[Docket No. NHTSA-2009-0190]

**Federal Motor Vehicle Safety
Standards; Bus Emergency Exits and
Window Retention and Release**

ACTION: Notice of proposed rulemaking (NPRM).

Figure 3D- REAR EMERGENCY EXIT WITHOUT REAR OBSTRUCTION

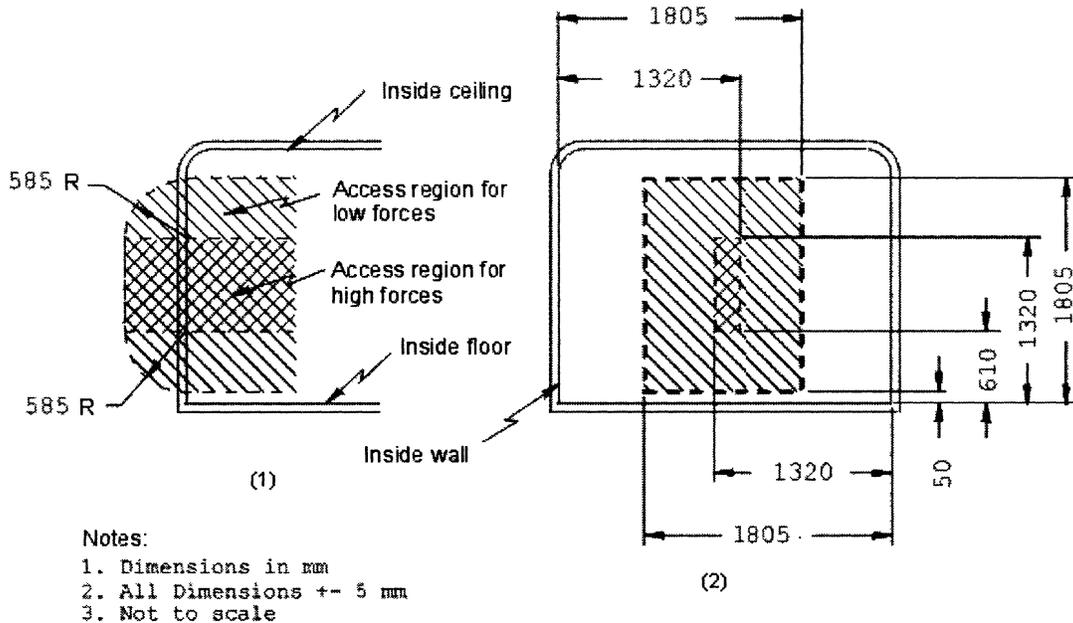
The School Bus Manufacturers’ Technical Council (SBMTC) petitioned the agency to amend FMVSS No. 217 to specify that the exterior release (handle) for school bus rear emergency exit doors may be located near the edge of the door on the side opposite the hinges. Specifically, SBMTC petitioned to amend S5.3.3.1(a) and one of the two drawings in Figure 3D.

S5.3.3.1(a) specifies that the manual interior and outside releases (handles) are located: “Within the high force access region shown in Figure 3A for a side emergency exit door, and in figure 3D for a rear emergency exit door.” Figure 3D consists of two drawings. The left-side drawing shows the vertical dimensions of the high force access region. As shown in the left-side drawing, the release (handle) may be located at any point from the left side of the door to the right. However, the right-side drawing, giving a different perspective of the rear exit, shows that the high force access region is a narrow area in the center of the door. Since S5.3.3.1(a) requires the interior and exterior releases (handles) to be “[w]ithin the high force access region shown in * * * figure 3D for a rear emergency exit door,” the releases must be in that narrow area in the center of the door shown in the right-side drawing of Figure 3D. As noted earlier, in actuality, SBMTC stated that manufacturers are “universally” placing the exterior releases on the side of the doors opposite the hinges.

SBMTC suggests that we reconcile the language of the standard with the practices of the industry and with what petitioner believes is best for safety. The petitioner suggests that we make the right-side drawing of Figure 3D apply only to the interior release (handle) and not to the exterior release. With regard to applying the right-side drawing to the interior release (handle), the petitioner believes there are reasons to require the interior release to be in the center of the door: the location ensures that the release is visible to bus occupants, and is not obscured by seat backs if the door is wider than the bus’s center aisle. Further, we note that the exit would be opened by a pushing rather than pulling

motion, so locating the handle in the center of the door does not markedly increase the difficulty of opening the door. However, since exterior releases (handles) are not obscured by seat backs, and since it is more difficult to open an exit by a pulling motion when the release (handle) is in the center of the door than when the handle is on the edge opposite the hinges, SBMTC believes that specifying a location in the center of the door serves no safety purpose for an exterior release.

NHTSA agrees. We propose amending the standard to specify that the interior release (handle) for a rear emergency exit must be in the high force access region shown in both drawings of current Figure 3D, and that the exterior release for the exit must only be in the high force access region shown in the left-side drawing of current Figure 3D. Although no manufacturer currently places the exterior release in the center of the door, we request comment on whether we should require the exterior release to be no further than two inches away from the edge of the door. (To clarify the standard, NHTSA proposes that instead of having Figure 3D consist of two drawings, Figure 3D would be easier to understand if the left-side drawing were renamed Figure 3D(1) and the right-side drawing were renamed Figure 3D(2).) We tentatively agree that the school bus manufacturers' current practice of placing the exterior rear emergency exit door release (handle) near the edge of the door on the side opposite the hinges better meets the need for safety than placing the exterior release in the center of the door. Releases (handles) placed opposite the hinges would require less force to pull open the door for persons outside the school bus.

2. Section 571.217 is amended by:
 - a. Revising S5.3.2(a), S5.3.2(b)(1) and (b)(2), S5.3.3.1(a), and the first sentence of S5.3.3.2;
 - b. Redesignating S5.3.3.3 as S5.3.3.4;
 - c. Adding a new S5.3.2.1 (a) and (b), S5.3.3.3 and S5.3.3.3.1;
 - d. Revising the first sentence of newly redesignated paragraph S5.3.3.4;
 - e. Adding S5.3.3.5 and S5.3.3.5.1 following S5.3.3.4(b)(3); and,
 - f. Revising Figure 3D.

(a) *Location:* Within the high force access region shown in Figure 3A for a side emergency exit door, within the high force access region shown in both Figure 3D(1) and Figure 3D(2) for an interior release mechanism for a rear emergency exit door, and within the high force access region shown in Figure 3D(1) for an exterior release mechanism for a rear emergency exit door.
